**Statement of Justification
The Collection
Limited Site Plan Amendment
Site Plan Nos. 82001021E and 82001013C
(Revised)**

82001013C & 82001021E - COMMENT LIST				
Cycle	Group	Comment Text	Update Date	RESPONSES
1	Maro Fuster	Any existing tree that was approved for credit on the 3/17/2011 FFCP and actually exists on the site in healthy condition will continue to be honored for the original credit amount. However there are a number of issues that need to be addressed in the current plans submission.	4/26/2016 0:00	A site visit was performed on April 29, 2016 for existing tree location verification. The credit table and landscape plan will compensate for those trees removed or not planted.
2	Maro Fuster	A number of the credited trees are dead, removed or in poor condition. Replacing the tree in kind will restore the original credit however the replacement plantings would need to be noted on the plan as applicable.	4/26/2016 0:00	A site visit was performed on April 29, 2016 for existing tree location verification. The credit table and landscape plan will compensate for those trees removed or not planted.

82001013C - PLAN MARK-UP COMMENT LIST

FOREST CONSERVATION PLAN

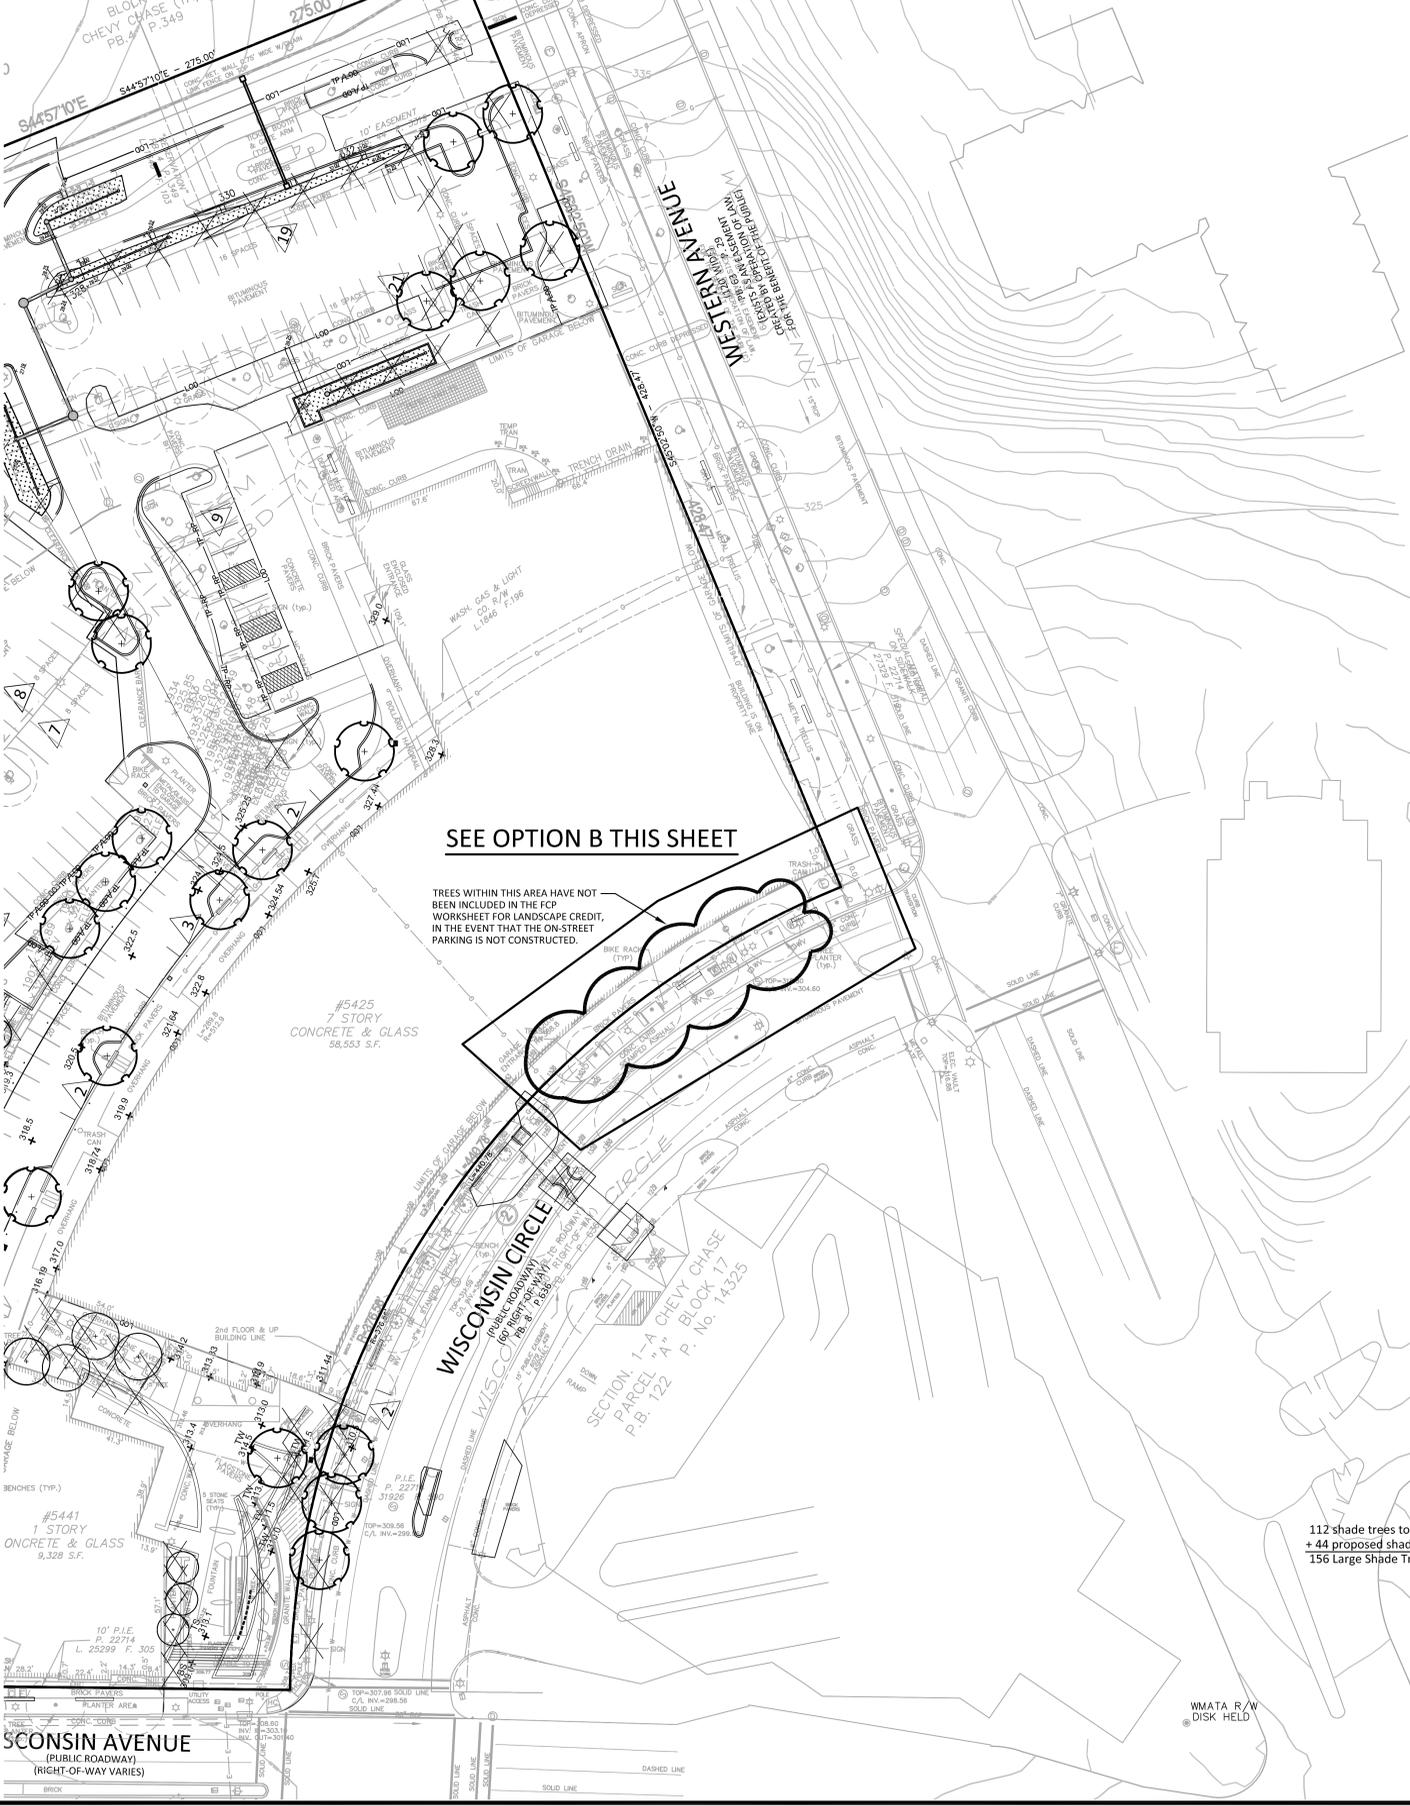
3	Maro Fuster	Some of the trees appear to have never been installed, for example there are areas where only 6 out of 7 credited street trees were installed.	4/26/2016 0:00	A site visit was performed on April 29, 2016 for existing tree location verification. The credit table and landscape plan will compensate for those trees removed or not planted.
4	Maro Fuster	Tree plantings at new locations need to follow current standards for credit.	4/26/2016 0:00	Understood.
5	Maro Fuster	The new trees in (or within) 5 feet of SWM facility/ROW or a conflicting easement will not qualify for FC credit.	4/26/2016 0:00	SWM trees have been removed from the FCP since credit for them can not be taken. SWM plantings will be reviewed and coordinated with DPS, and follow the 5 foot perimeter requirement.
6	Maro Fuster	See change marks.	4/26/2016 0:00	Understood. We have reviewed changemarks along with the written comments.

10-BFCP-82001021E-001	Marco Fuster	The trees in (or within) 5 feet of new SWM facility will not qualify for FC credit.	4/26/2016 0:00	SWM trees have been removed from the FCP since credit for them can not be taken. SWM plantings will be reviewed and coordinated with DPS, and follow the 5 foot perimeter requirement.
10-BFCP-82001021E-001	Marco Fuster	The Xs in some locations are confusing as they coincide over a newly planted tree. Additional sheets or clearer graphics are needed.	4/26/2016 0:00	Some existing trees are being removed for construction purposes and replaced with new trees in the same locations. The graphics of the FCP have been made much clearer by utilizing a cadd base instead of a scan of the previously approved plan (done after a phone conversation with Marco). Xs remain and the proposed trees have been made bolder.
10-BFCP-82001021E-001	Marco Fuster	More information is needed on the appropriateness of the setting for these trees. For example the trees proposed along Montgomery Street appear to be planted at the edge of pavement causing a number of issues.	4/26/2016 0:00	The location of the proposed trees has been made more clear. Also see the landscape set for the tree pits proposed for these trees.

10-BFCP-82001021E-001	Marco Fuster	A 24 inch diameter oak tree located in this area is in notable decline and potentially hazardous. Tree should be noted for removal. A replanted tree could be credited at this location.	4/26/2016 0:00	There are no proposed construction or changes located around this tree. An arborist will be coordinated with, during preconstruction to determine if the tree should be proposed for removal. Should the tree be identified for removal, a replacement tree will be planted in its place. The plan now reflects the removal and replacement so future plan changes will not be needed.
10-BFCP-82001021E-001	Marco Fuster	The new trees in (or within) 5 feet of SWM facility/ROW or a conflicting easement will not qualify for FC credit.	4/26/2016 0:00	SWM trees have been removed from the FCP since credit for them can not be taken. SWM plantings will be reviewed and coordinated with DPS, and follow the 5 foot perimeter requirement.

10-BFCP-82001021E-001	Marco Fuster	This credited tree is in poor condition due to the overhanging Boxelder tree. Oak tree should be replaced along with notes to prune portions of the boxelder to accommodate the replacement planting.	4/26/2016 0:00	The oak tree in question will be removed. Replacement for this removal has been accounted for on the site. As a result of removal of the Oak, the Boxelder tree should not need the suggested pruning. The arborist can inspect this tree and provide guidance. No proposed construction is slated for this area.
10-BFCP-82001021E-001	Marco Fuster	This tree is shown 1 foot behind curb. Move trees to realistic setting, further from areas subject to vehicle /plow damage.	4/26/2016 0:00	Tree locations have been revised to remove this concern.
10-BFCP-82001021E-002	Marco Fuster	Revise plantings and associated credit/requirements per comments herein.	4/26/2016 0:00	We have revised the planting and layout per comments.

SU-30 AUTOTURN

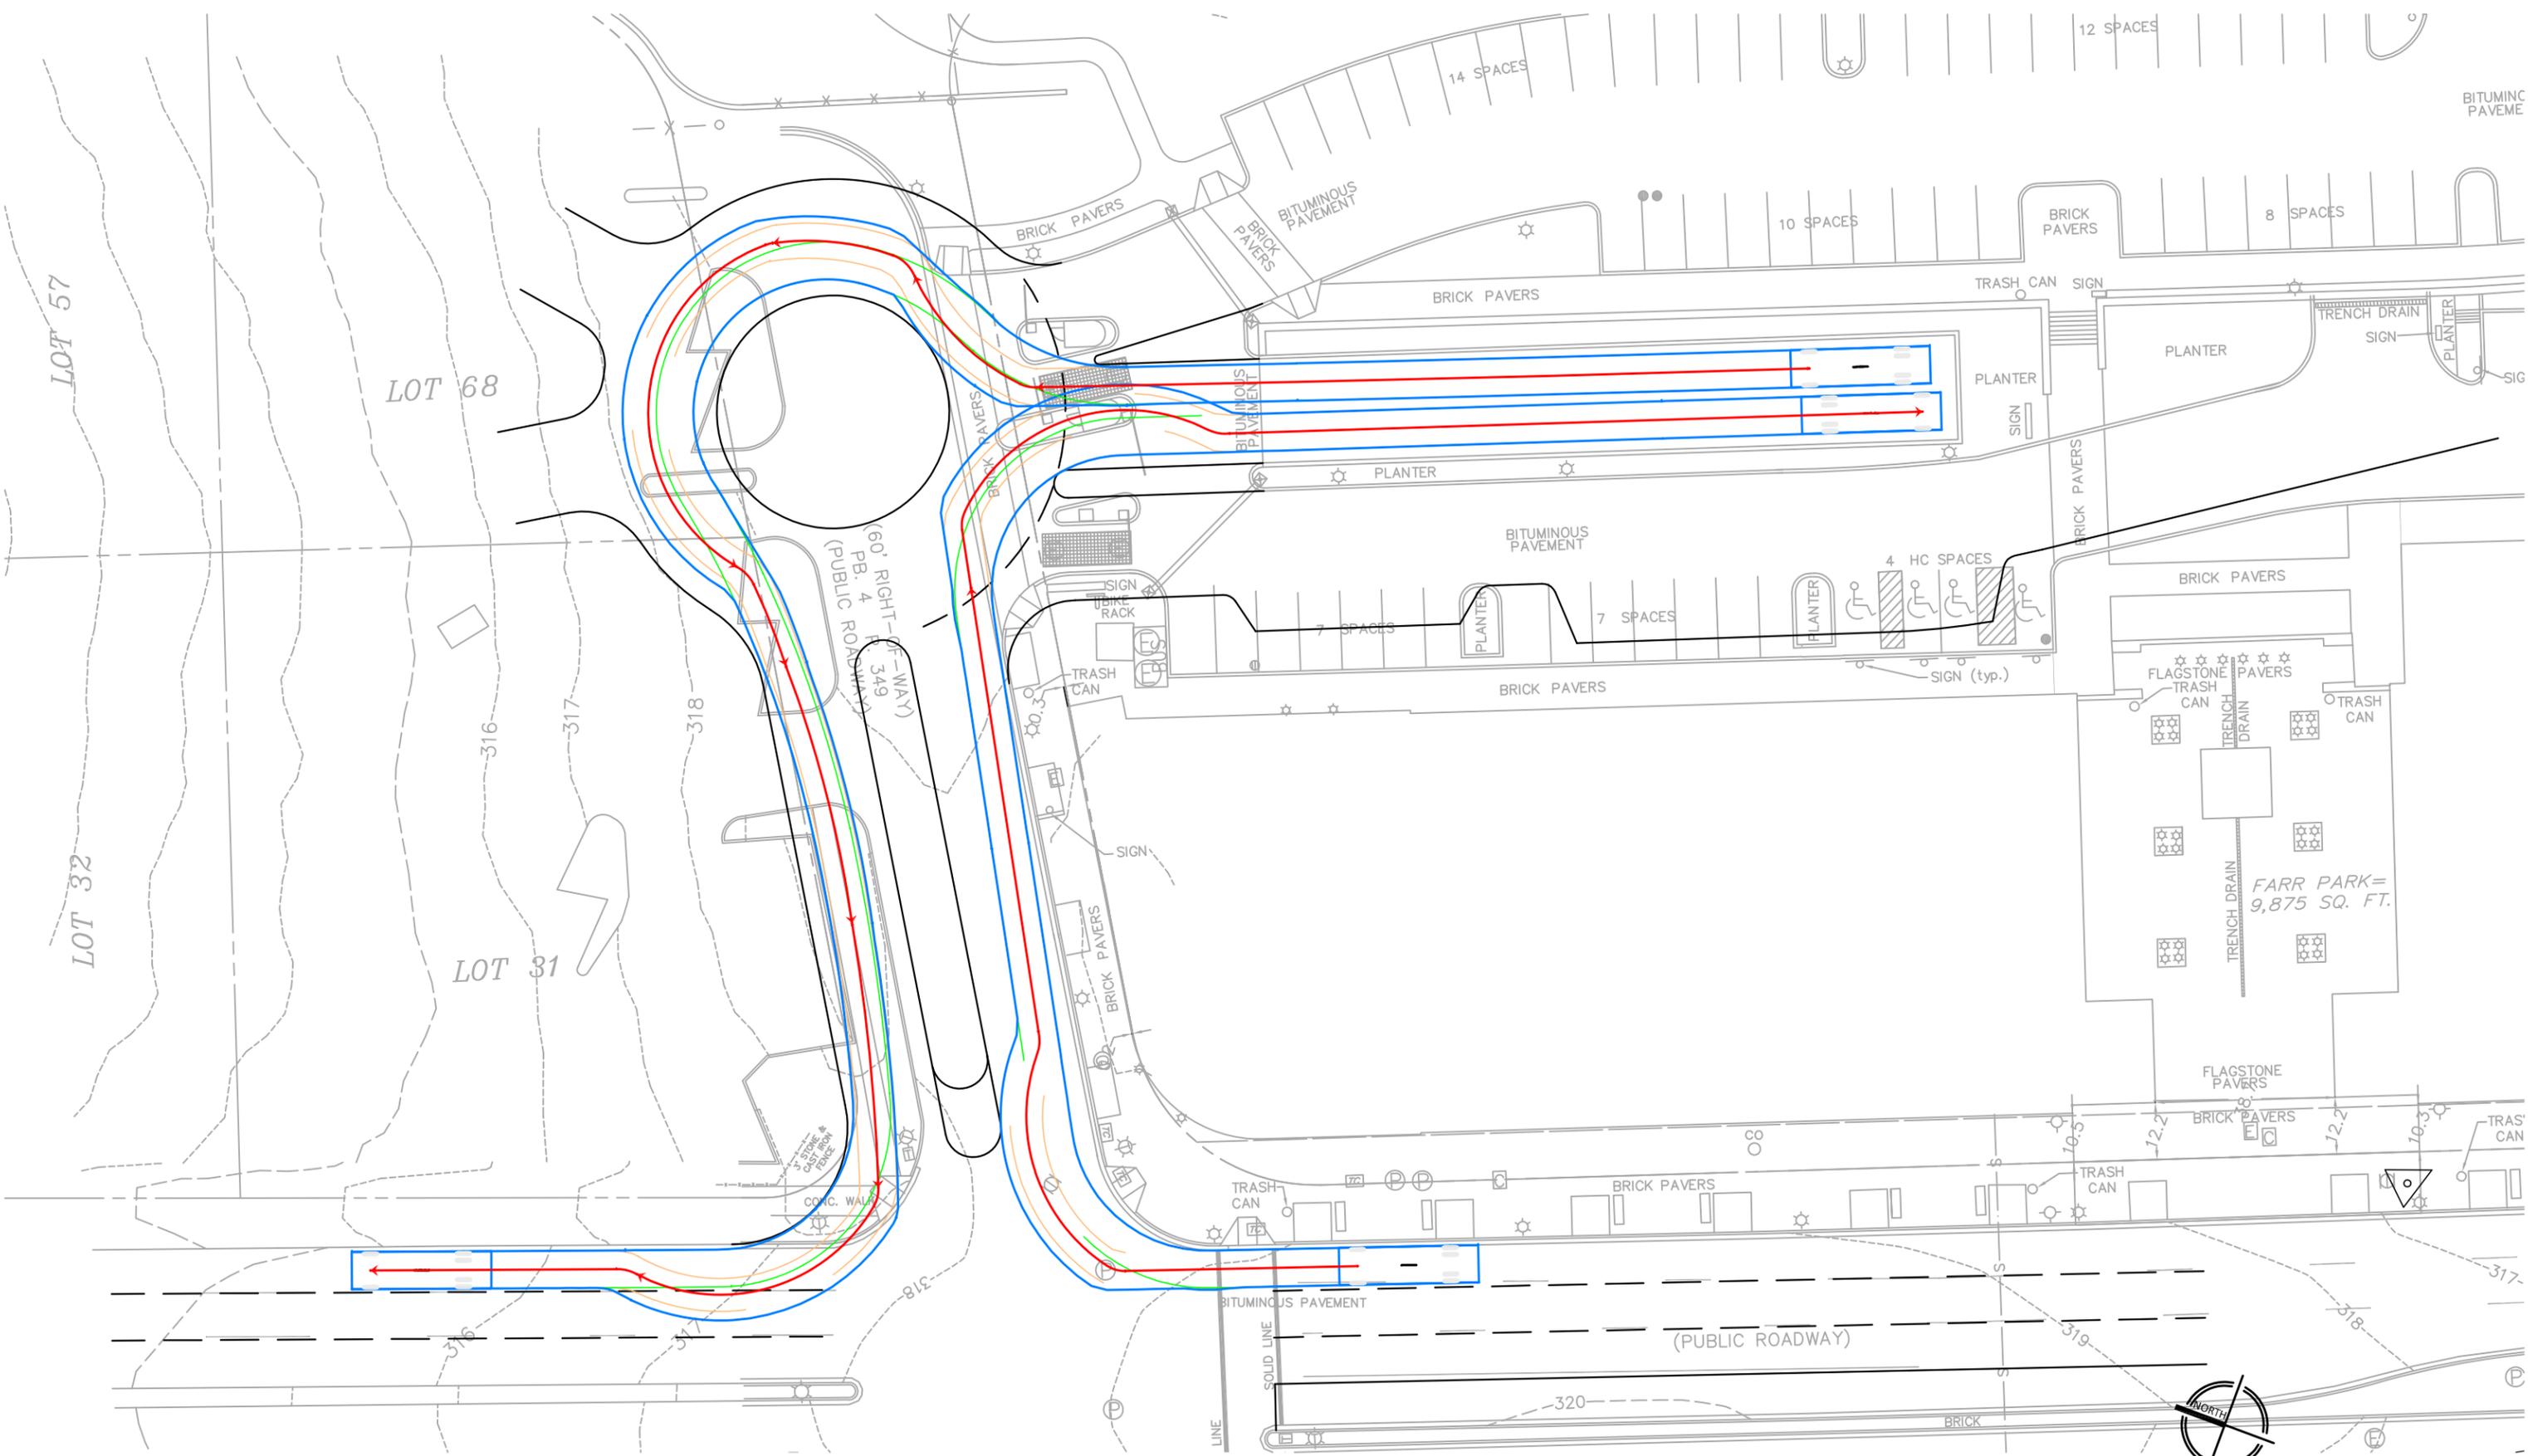
1	Stephanie Dickel	Add "or approved equal" to all details on Sheet LS2.0 and 2.1 to allow flexibility.	4/26/2016 0:00	This note has been added.
2	Stephanie Dickel	Please separate the hardscape/site furnishings plan from the landscape plan and provide two separate plans.	4/26/2016 0:00	These plans have been separated.
3	Stephanie Dickel	Please provide an overall landscape plan showing proposed new landscaping and existing landscape to remain.	4/26/2016 0:00	We have provided this.
4	Stephanie Dickel	Please update the landscape plans to reflect the existing landscaping, quantities, and material.	4/26/2016 0:00	Existing information is reflected on the plan.
5	Stephanie Dickel	**These comments are for both 82001021E and 82001013C**	4/26/2016 0:00	Understood.
1	Mathew Folden	please provide a turning template indicating that the design vehicle can be accommodated on-site.	4/26/2016 0:00	A truck turning exhibit has been included.

10	Sam Farhadi	Please provide truck turning movements.	4/26/2016 0:00	This is one way in for passenger vehicle entry to the parking garage. There is no exit permitted onto Wisconsin Circle from this location.
11	Sam Farhadi	Provide sight distance analysis.	4/26/2016 0:00	This is one way in for passenger vehicle entry to the parking garage. There is no exit permitted onto Wisconsin Circle from this location.
12	Sam Farhadi	Narrow the median break at the intersection of Wisconsin Circle and Wisconsin Ave to 18' with 2' nose curb radius instead of proposed 1'.	4/26/2016 0:00	Curb alignment has been revised. Please see plan.
